PRODUCT ADVISORY

**Data Sheet Specification Change for
Intersil Products ISL59601*,
ISL59602*, ISL59603*, ISL59604*,
and ISL59605***

**Refer to:
PA12072**

Date: September 6, 2012

- Figure 45 – Application Circuit for UTP Cable (Page 20):

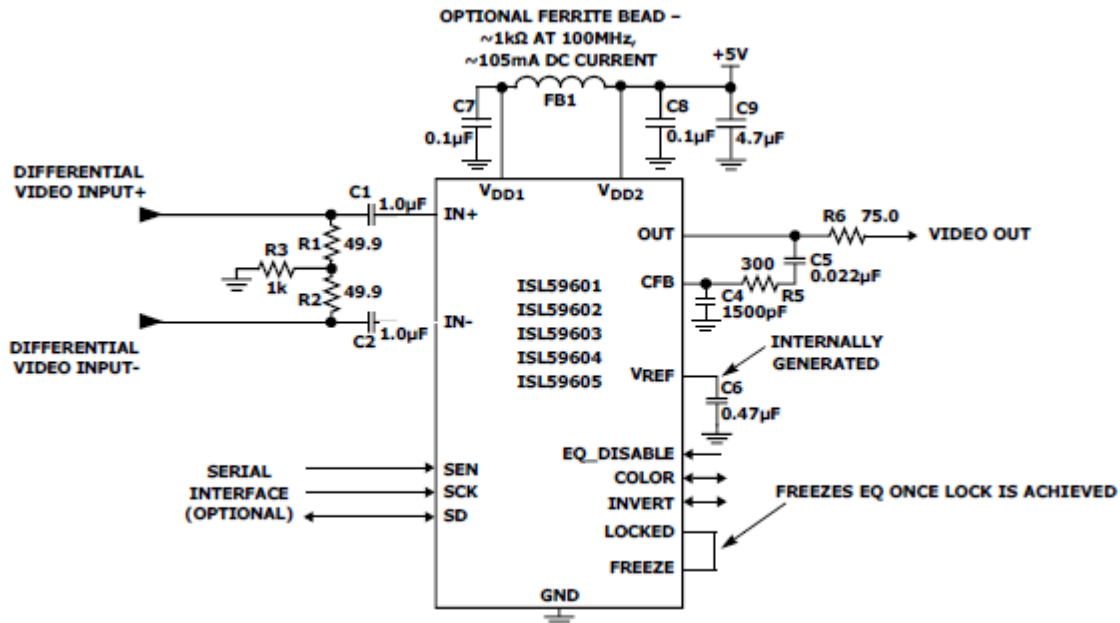
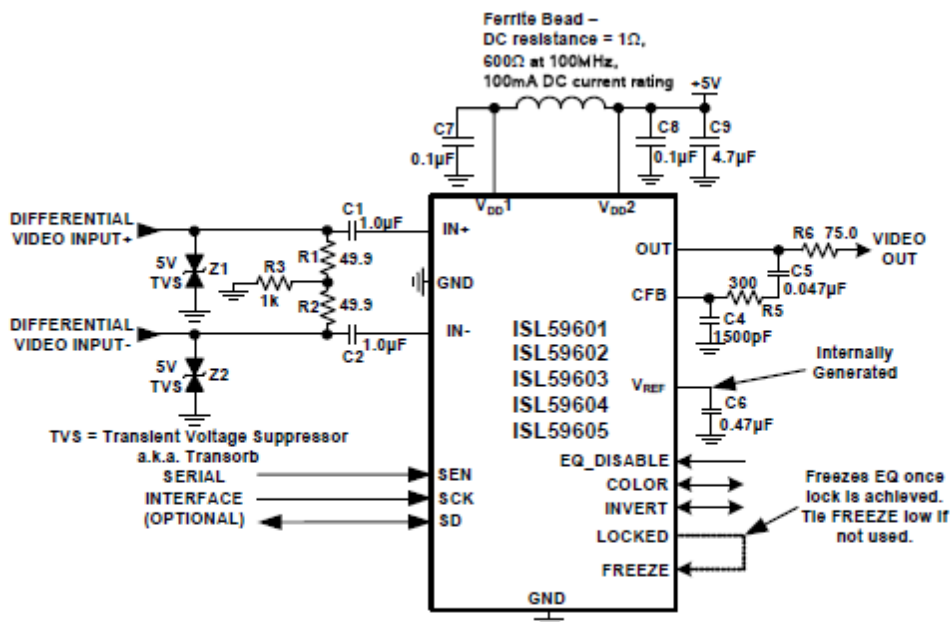
Change From:

Change To:

- Figure 46 – Application Circuit for COAX Cable (Page 21):

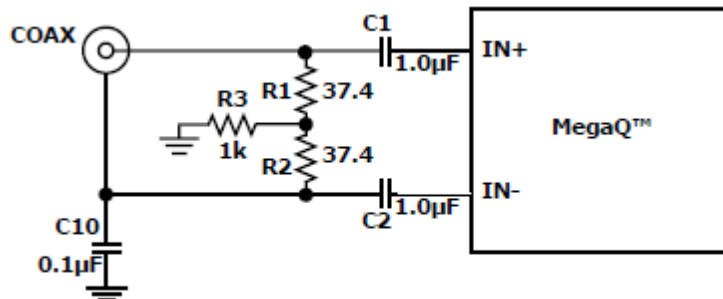
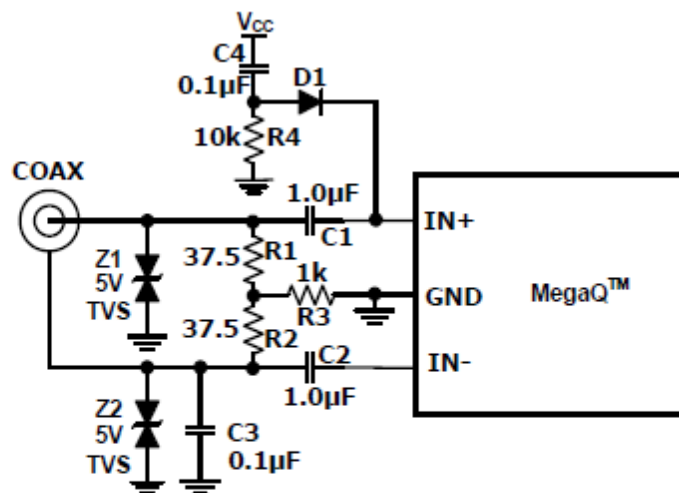
Change From:

Change To:

TVS = Transient Voltage Suppressor
a.k.a. Transorb

- Figure 47 – Application Circuit for UTP/COAX Cable (Page 21):

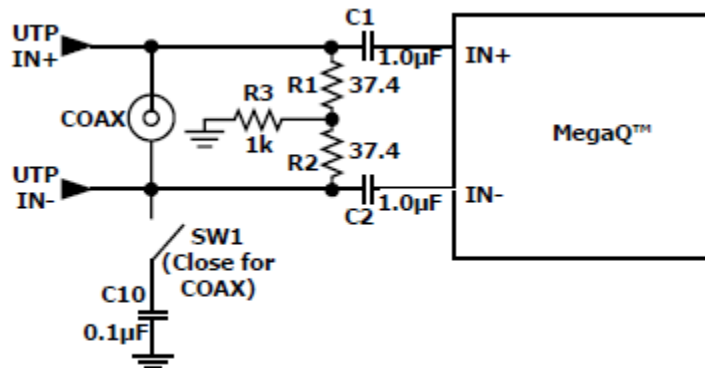
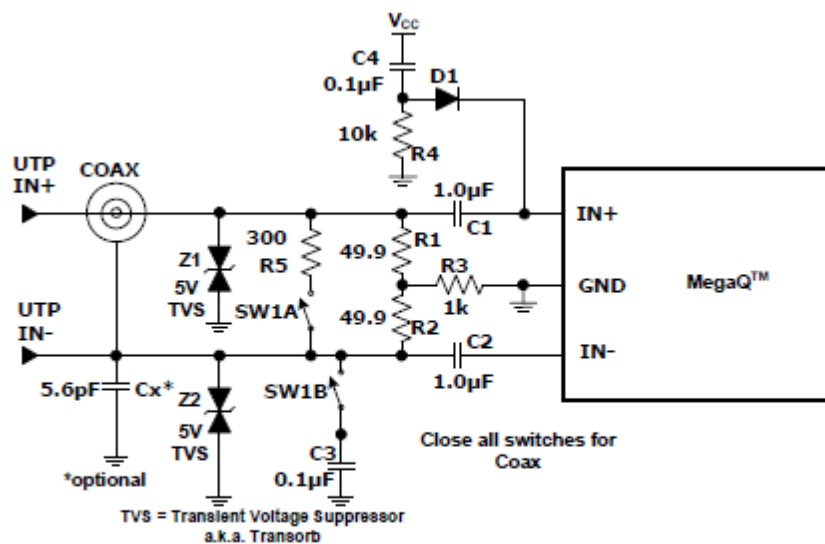
Change From:

Change To:
